**DATE:** April 5, 2022  
**TO:** Franklin Planning Board  
**FROM:** Department of Planning and Community Development  
**RE:** Washington Street Flex Space  
Site Plan - Endorsement

**CERTIFICATE OF VOTE**  
Site Plan  
Washington Street

RE: Site Plan - Washington Street Flex Space

SITE PLAN  
 PARKING AND PHASING SKETCH PLAN  
 275 WASHINGTON STREET  
 FRANKLIN, MASSACHUSETTS  
 PREPARED FOR  
 FRANKLIN FLEX SPACE, LLC  
 13 CLOVELLY ROAD  
 WELLESLEY, MASSACHUSETTS  
 JUNE 28, 2021  
 SCALE: 1" = 40'

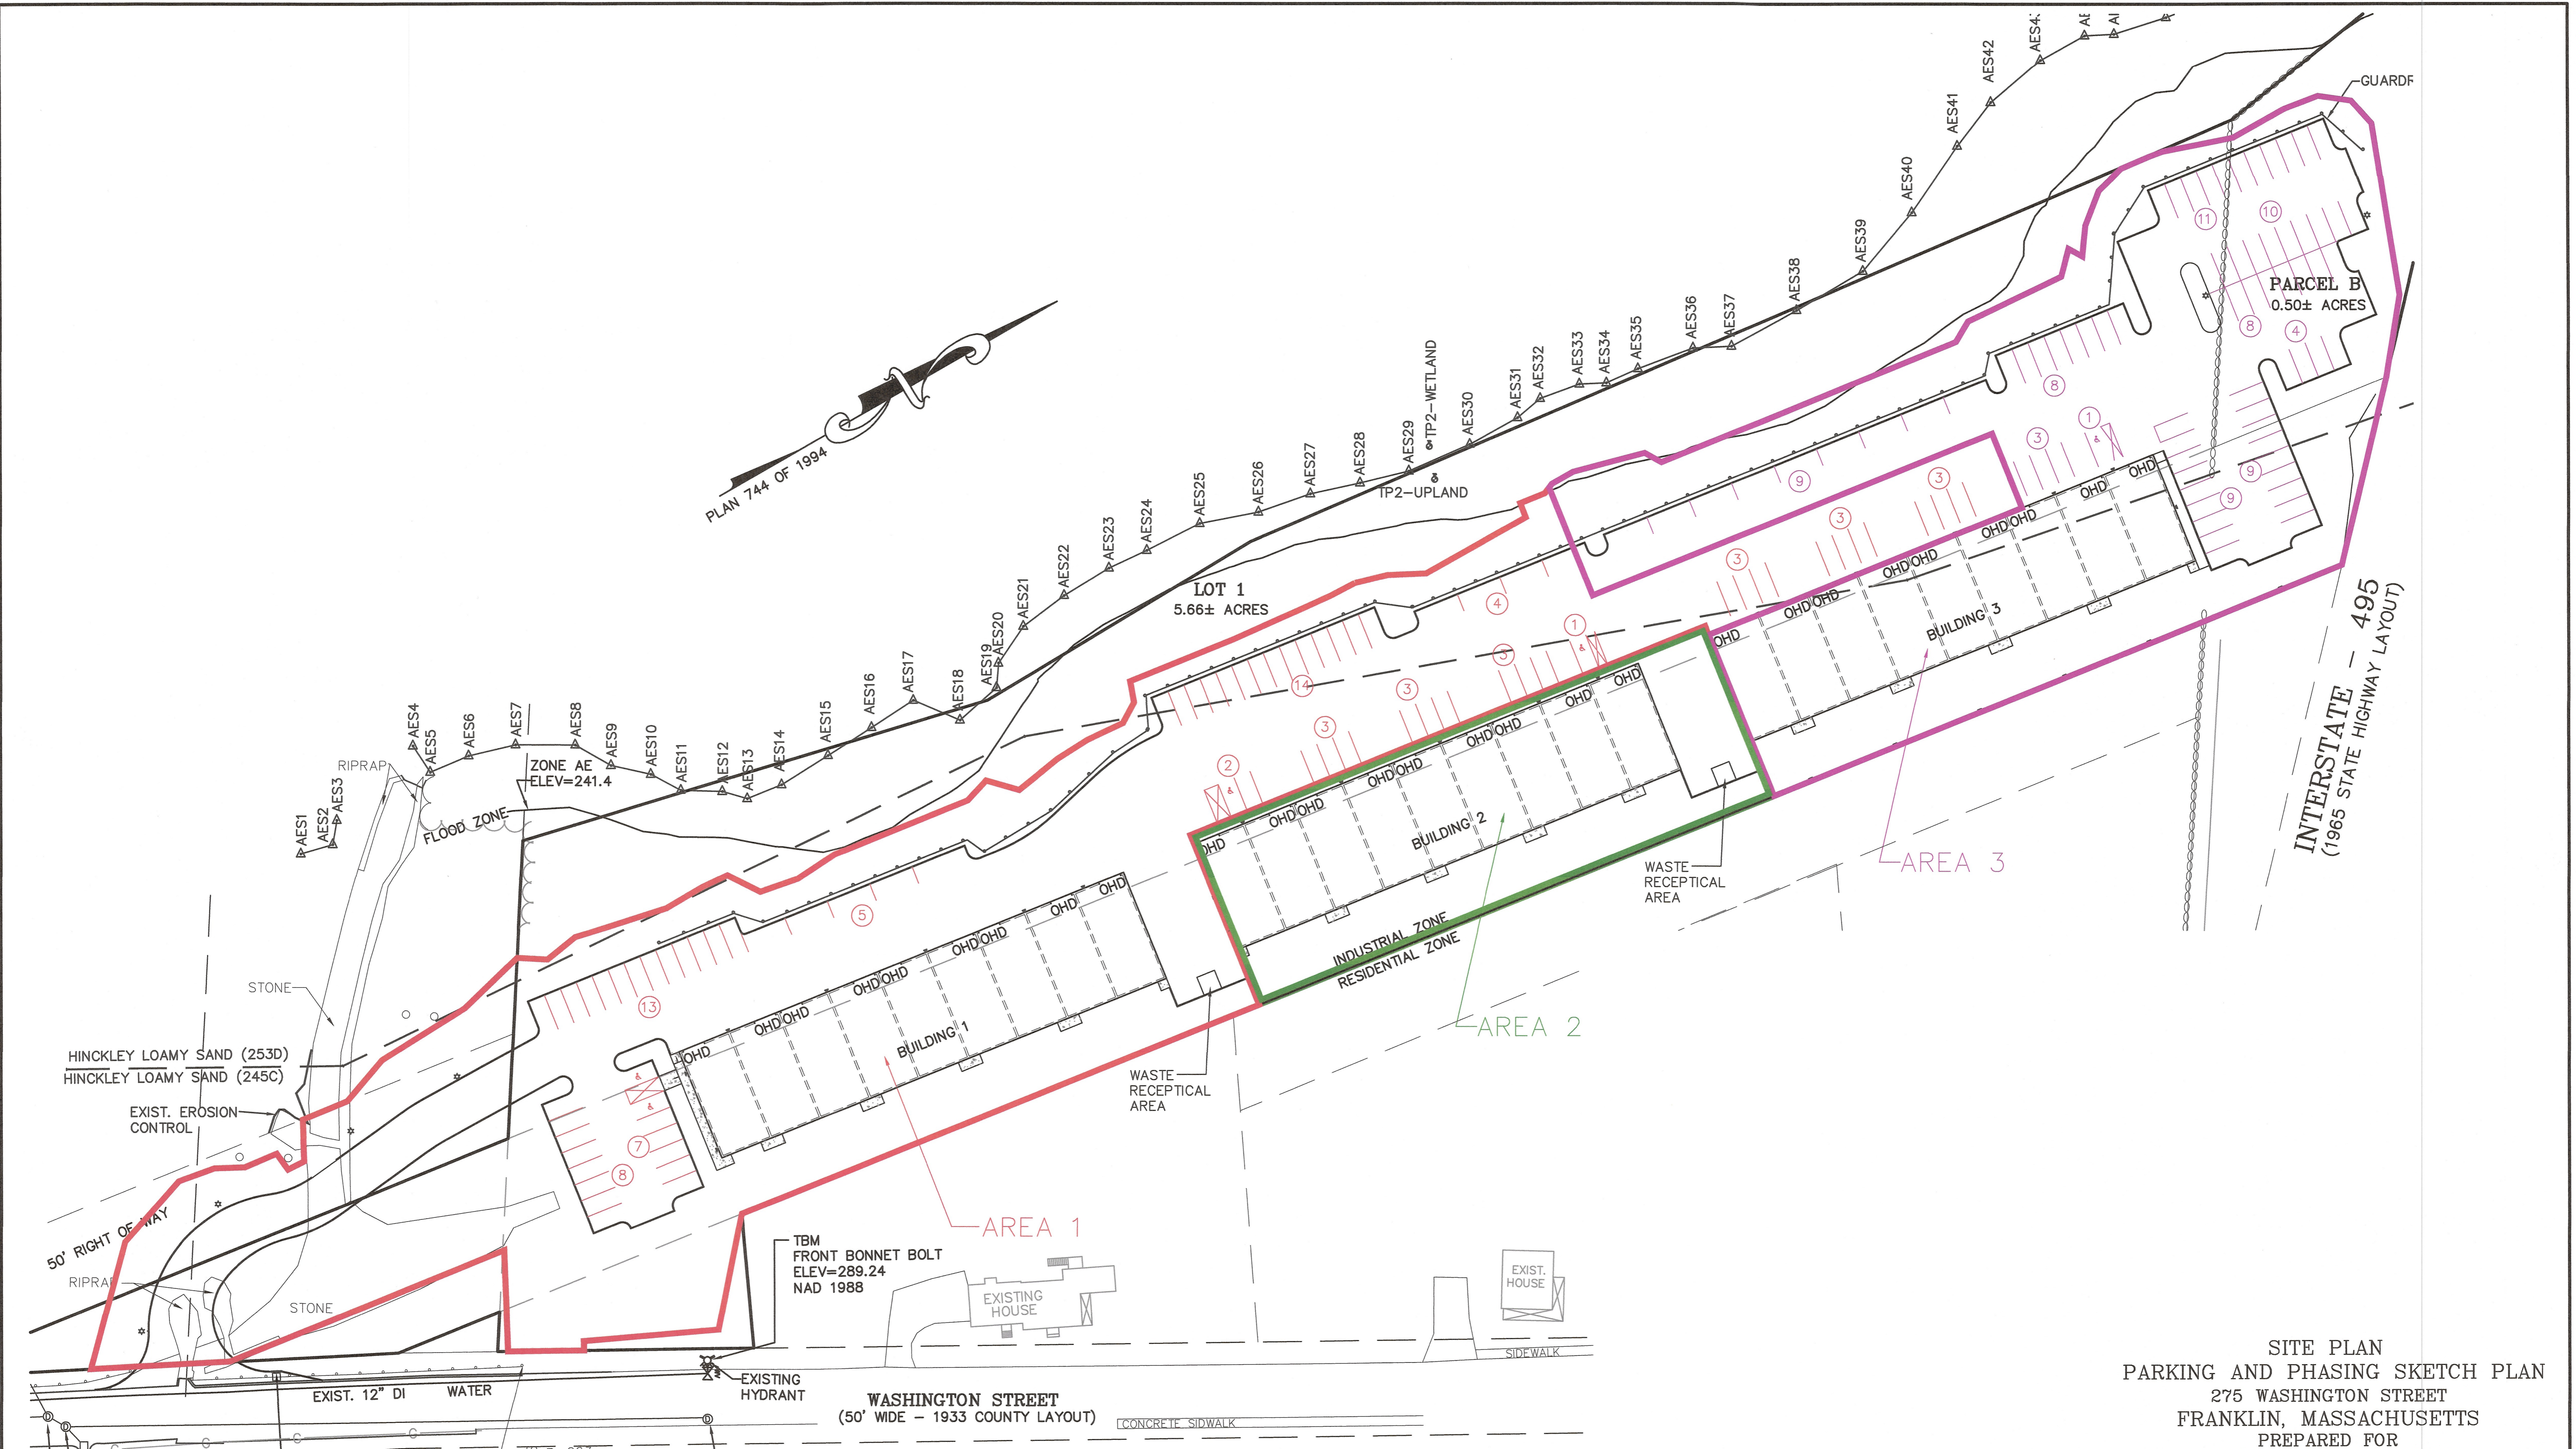
- Prior to endorsement, provide a color sketch outlining each phase with parking spaces.
- The owner will not be allowed to lease or sell units to tenants with industrial activities that are subject to the NPDES Multi-sector permit. All industrial activities will take place within the building.

1. The Planning Board voted to approve the Site Plan for Washington Street Flex Space on February 28, 2022.
2. The following are Special Conditions to be met prior to endorsement:
  - a. The retaining wall details are to be submitted and reviewed prior to the start of the construction. *Details have been submitted*
  - b. Prior to endorsement, a note will be added to the plans to say -The builder will have a structural engineer on site during the construction phase to design a wall where needed using large boulders or concrete blocks, as stated in the attached letter from Mike Maglio, Town Engineer *Note added to page 5 of the plans*
  - c. Prior to endorsement, provide a color sketch outlining each phase with parking spaces. *Plan has been submitted*
